File No.: 04-1000-20-2020-335 & 2020-337

Re: **Request for Access to Records under the Freedom of Information and Protection of Privacy Act (the "Act")**

Records regarding the development project at 3365 Commercial Drive and 1695 to 1775 East 18th Avenue (DP-2017-00181/BP-2017-05913):

Date ranges: February 23, 2017 to April 20, 2018 (Development Permit Application review) and September 8, 2017 (Community Services Group, Development Services, stamped "Received" a Development Application Number DP-2017-00181, prepared by Yamamoto Architecture)

CD-1 Bylaw section 5.3

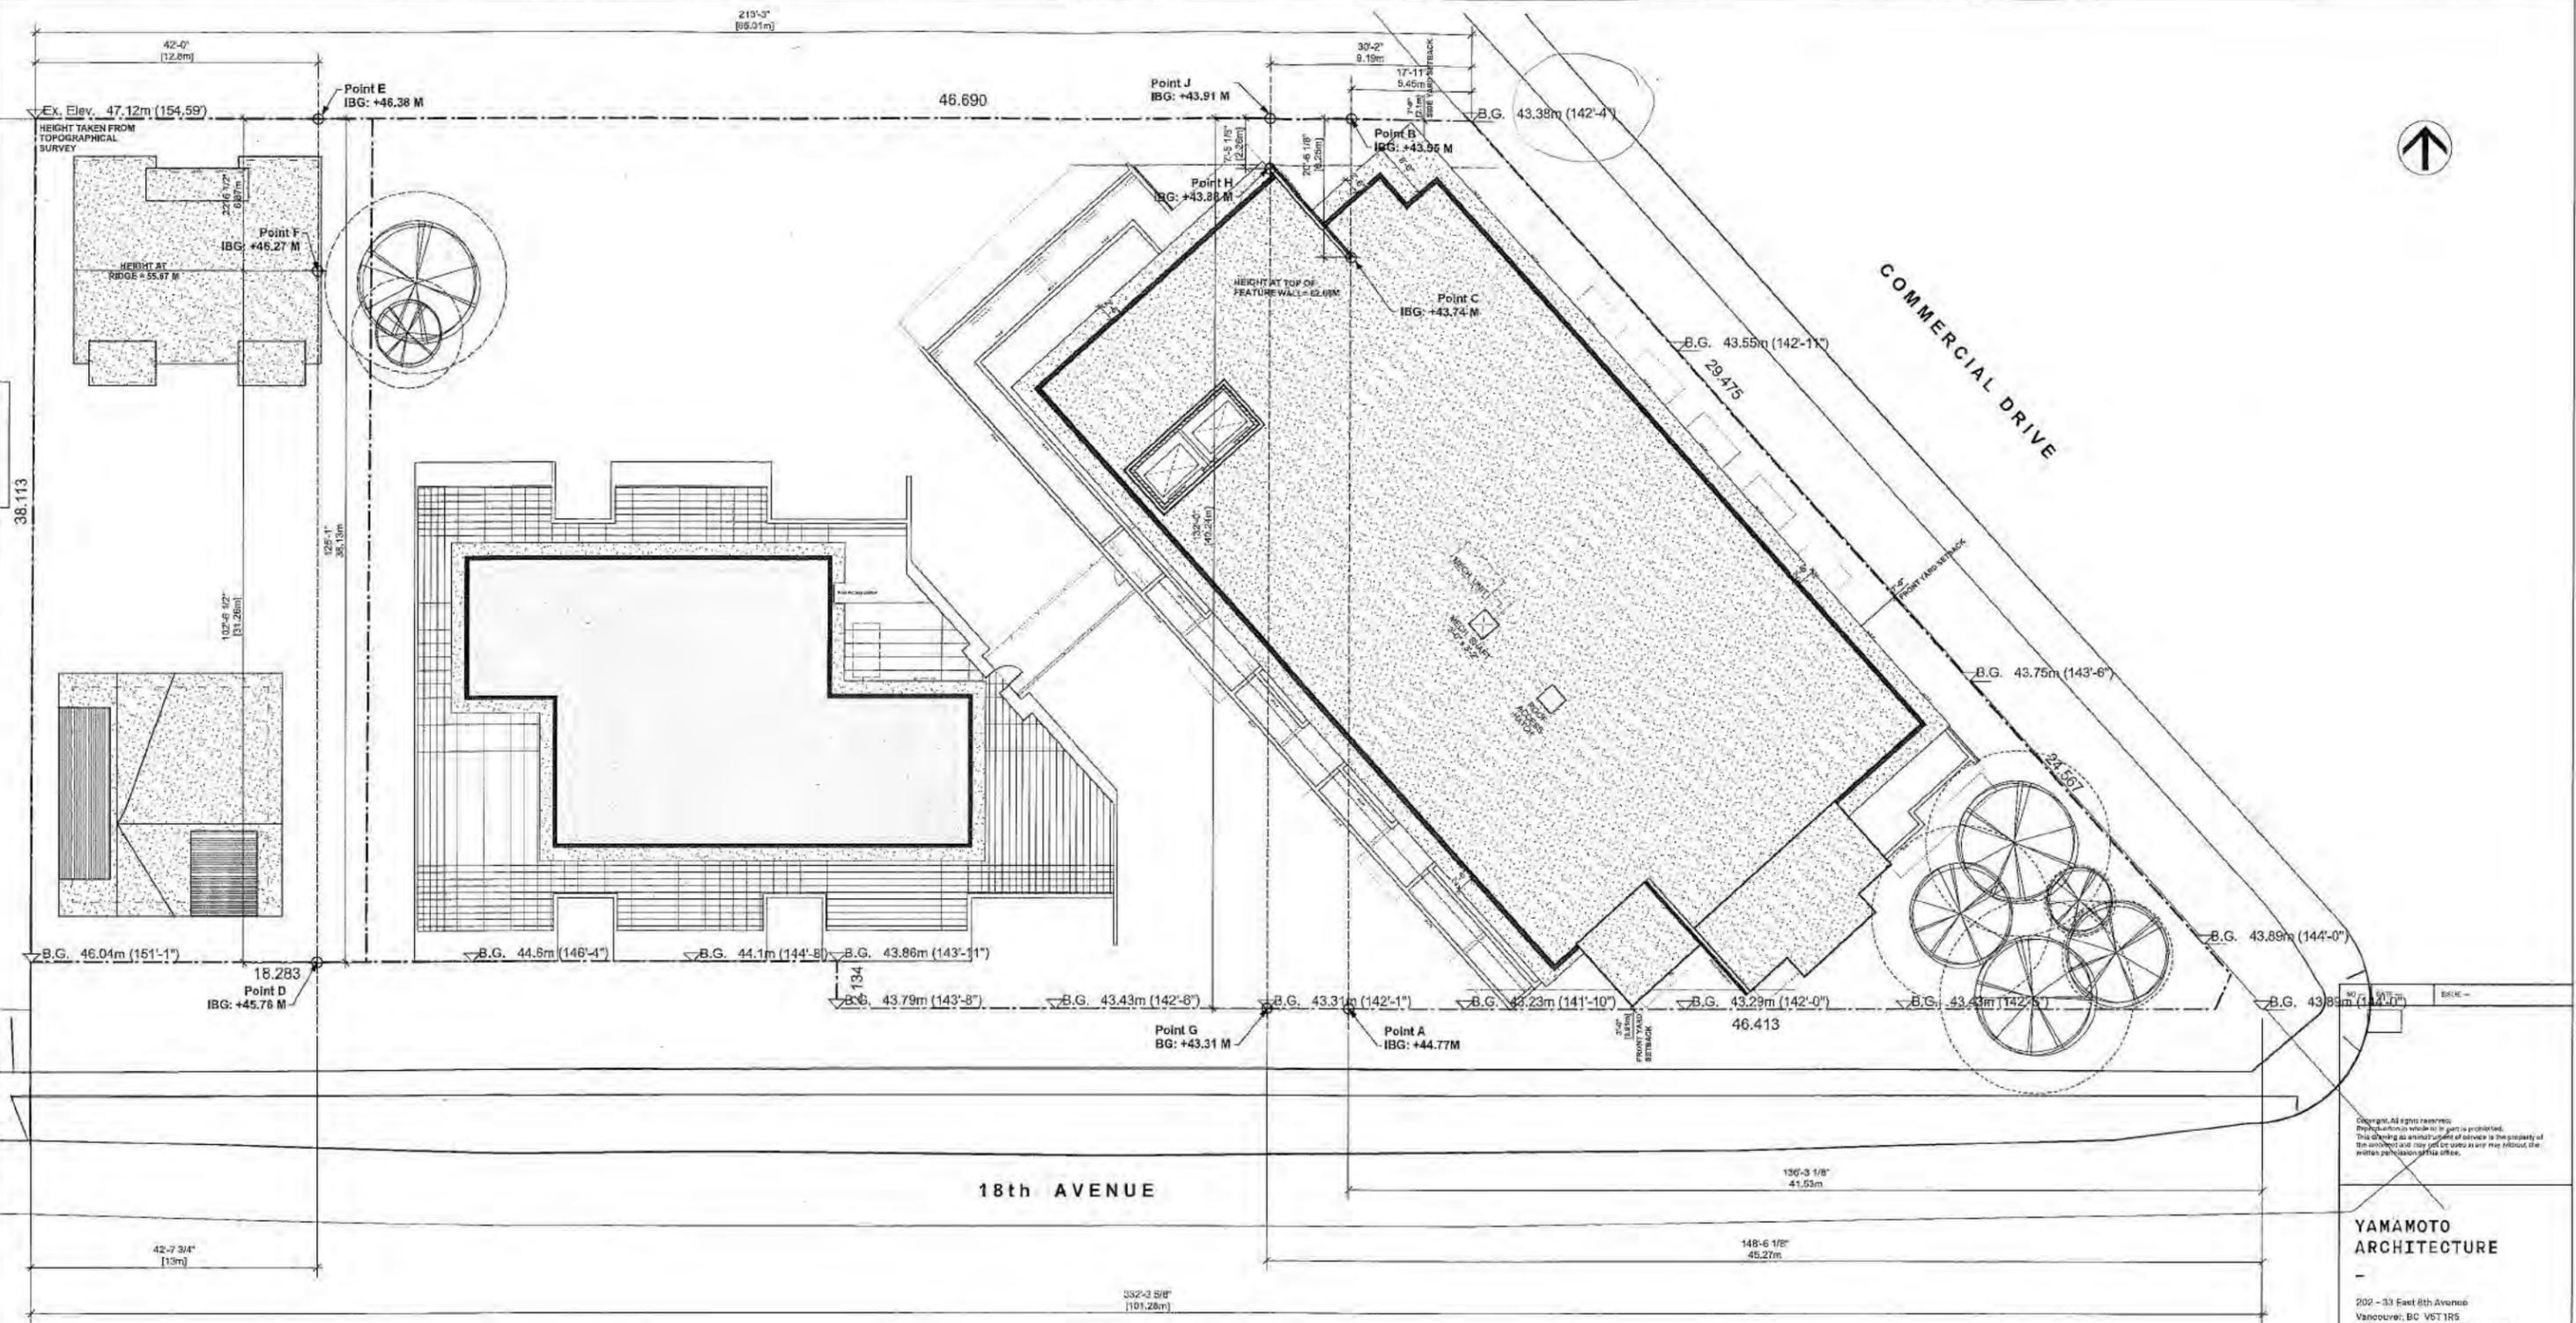
Sub-area # 1- maximum permitted floor area (m²) = 6855 m² (2.55 FSR) (not 2.70 FSR)

In the meantime, can you please confirm you are designing to 2.55 FSR (and excluding storage) and not 2.70 FSR?
